**SUBDIVISION, PLANNING APPROVAL  
PLANNED UNIT DEVELOPMENT  
& SIDEWALK WAIVER STAFF REPORT**

**Date: February 7, 2008**

County Club of Mobile

Country Club of Mobile Subdivision

# SITE PLAN

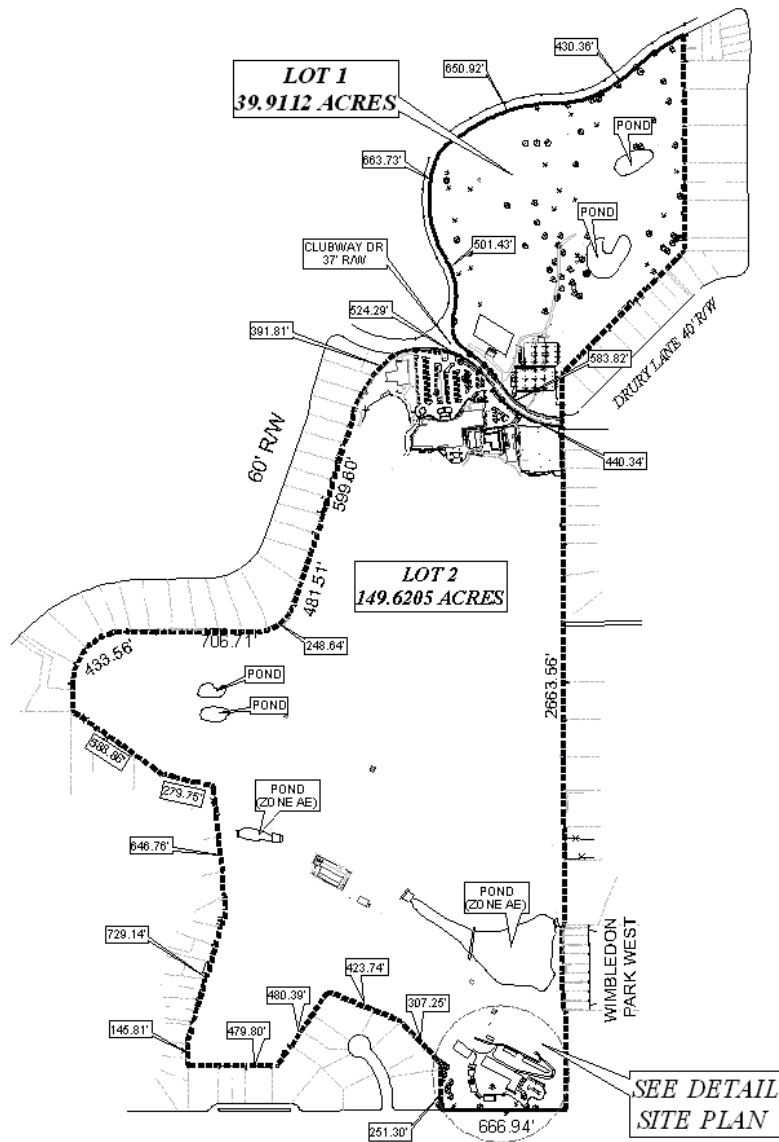
With regard to the Subdivision request, as stated above, the purpose of the application is to incorporate multiple metes and bounds parcels into two legal lots of record. The plat submitted illustrates the required 25' building setback, and labels each lot in acres – which given the overall size of the lots would be acceptable in lieu of square feet.

As indicated on the site plan, access to this facility is to be via a new drive to Airport Boulevard, a major street with existing right-of-way of 140' at this location. As Airport Boulevard is a major street, access management is a concern. The narrative submitted with the application indicates that the access drive is to be gated, however the site plan submitted indicates that the only gated area is from the drive to what appears to be the maintenance area. If approved, the drive from Airport should be gated to limit its use to maintenance vehicles or vehicles of those individuals located in the 2,050 sq ft of office space, and to deter any use of this drive by the public. The gate should be located at or near the 25' building setback line to allow a vehicle to completely enter the site prior to approaching the gate.

The plan illustrates significant natural buffers along the East, West and South property lines. These buffers far exceed the minimum requirements of the Zoning Ordinance, and given the nature of the use of the property are more appropriate than a simple 6' wooden privacy fence.

## DETAIL SITE PLAN

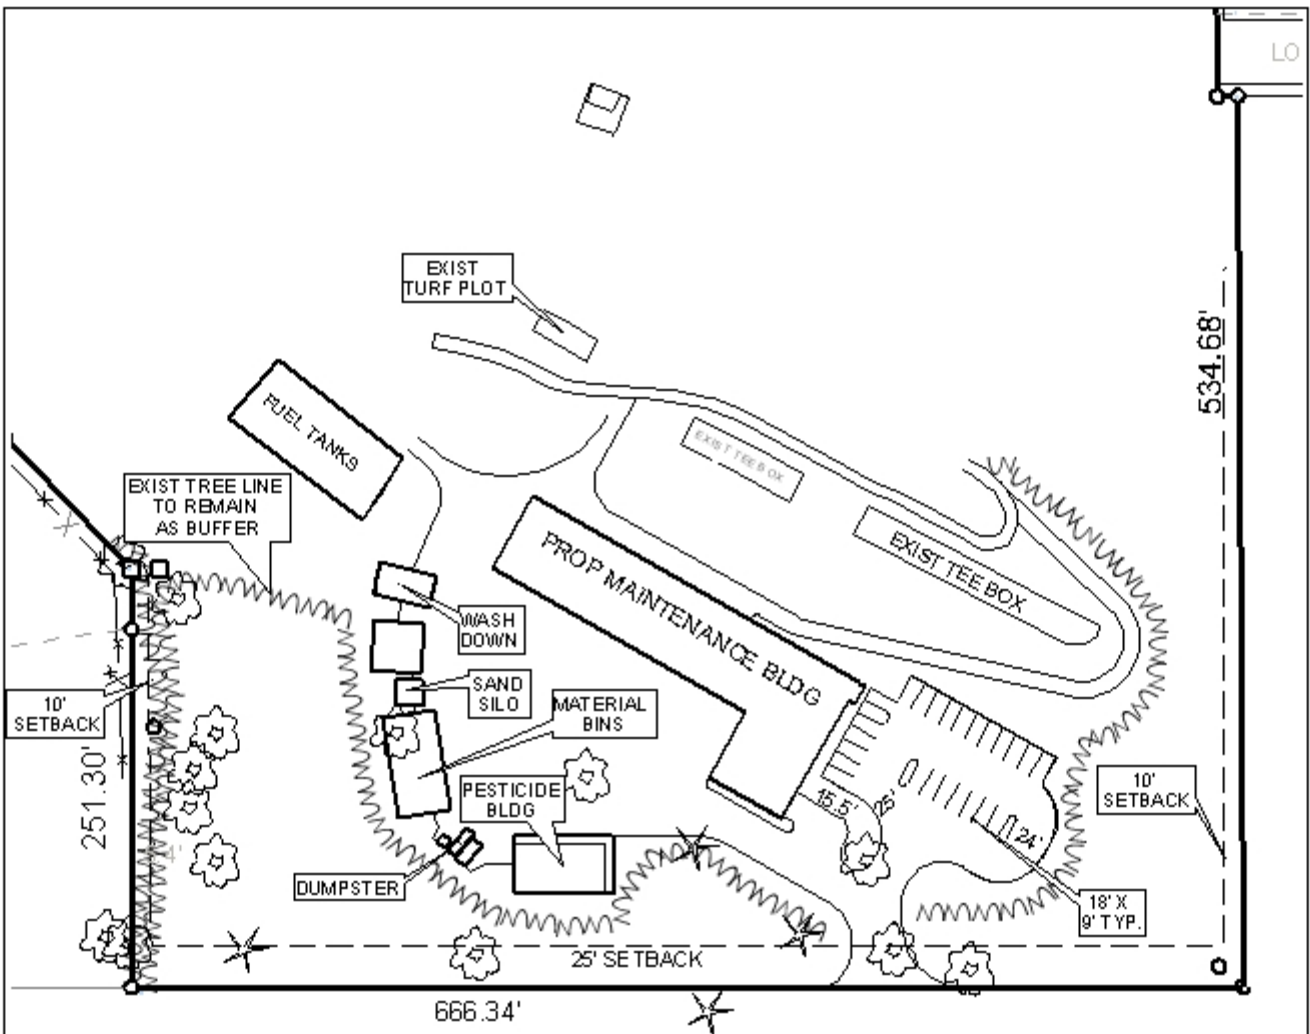
Other points that should be addressed by the applicant are the environmental issues or concerns relating to the pesticide building, the location of any detention facility, if required, and approval of the fueling tanks/system by the Mobile Fire Department. Additionally, signage on Airport Boulevard indicating trucks (or vehicles) entering the street may be appropriate East of the drive to notify motorists of that potential. While there are no such signs existing along this section of Airport Boulevard, the site in question has not had access in the past and the natural buffer that is to remain would appear as if the land is undeveloped and therefore it would appear as if there were no access.

**Planning Approval:** Based upon the preceding, this application is recommended for holdover until March 6 to allow the applicant to address issues referenced in the remarks section of the report (ie. Exact location of curb cut to Airport Boulevard and location of proposed gate, location of detention facilities, MFD approval of fuel tanks, environmental issues surrounding the pesticide building, lighting of parking facility, etc), and to allow the application to be considered with the accompanying Subdivision, Planned Unit Development, and Sidewalk Waiver applications. Additional information must be submitted by February 15.

**Planned Unit Development:** Based upon the preceding, this application is recommended for holdover until March 6 to allow the applicant to address issues referenced in the remarks section of the report (ie. Exact location of curb cut to Airport Boulevard and location of proposed gate, location of detention facilities, MFD approval of fuel tanks, environmental issues surrounding the pesticide building, lighting of parking facility, etc), and to allow the application to be considered with the accompanying Subdivision, Planning Approval, and Sidewalk Waiver applications. Additional information must be submitted by February 15.

## CROSS SECTION DETAIL

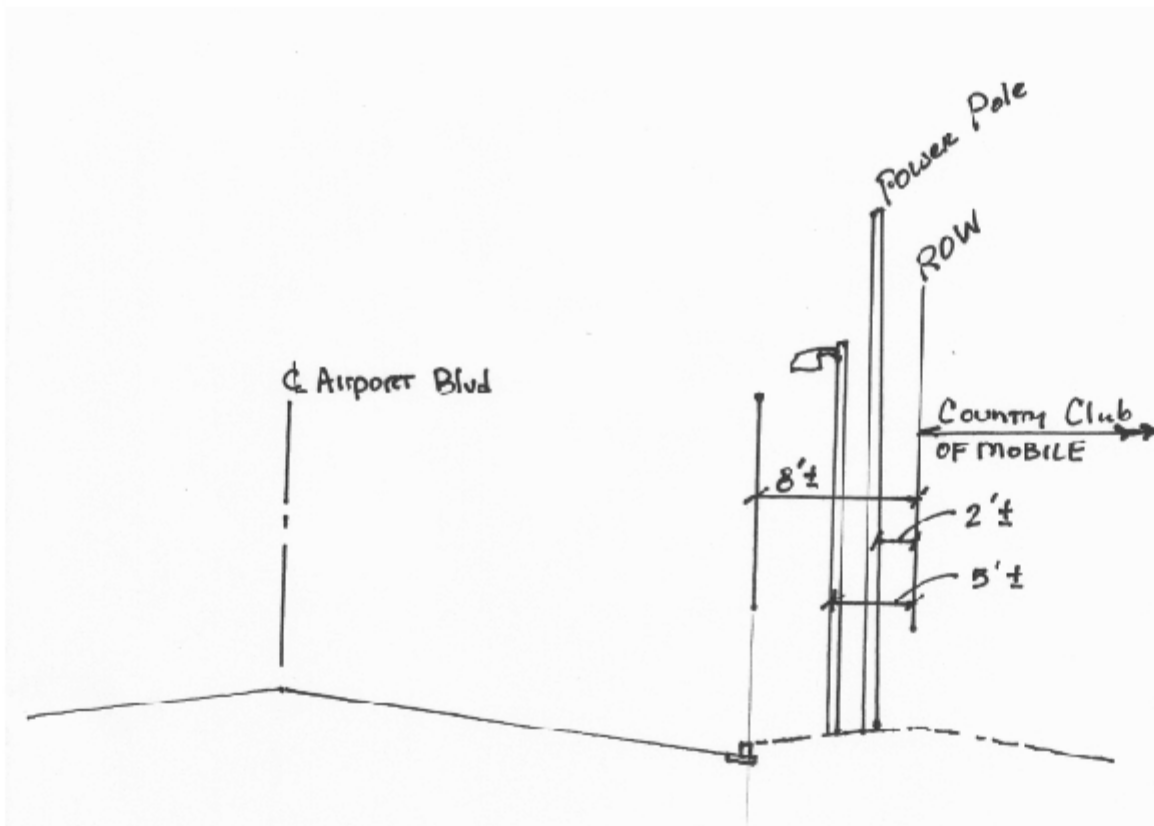
With regard to the Sidewalk Waiver Request, the applicant contends that the sidewalk should be waived because there are not existing sidewalks present in along this section of Airport Boulevard and the existing light and power poles would conflict with sidewalk location.

The applicant is correct in that there are no existing sidewalks in this area. However, the Commission has rarely allowed the absence of sidewalks in an area as justification for the granting of a sidewalk waiver. Based on the site plan and cross-section provided by the applicant, it appears that the existing power poles and light poles, which range from 2' to 5' from the property line would conflict with the sidewalk if placed in the standard location. Given the distance remaining from light poles to the back of curb, 8', it is questionable if the placement of a 4' sidewalk within that area would be desirable. On the other hand, the provision of a sidewalk in that area would seem more desirable than pedestrians walking along this section of Airport Boulevard with no sidewalk or defined or delineated walking path.

**Sidewalk Waiver:** Based upon the preceding, this application is recommended for holdover until March 6 to allow the application to be considered with the accompanying Planning Approval, Planned Unit Development, and Sidewalk Waiver applications.
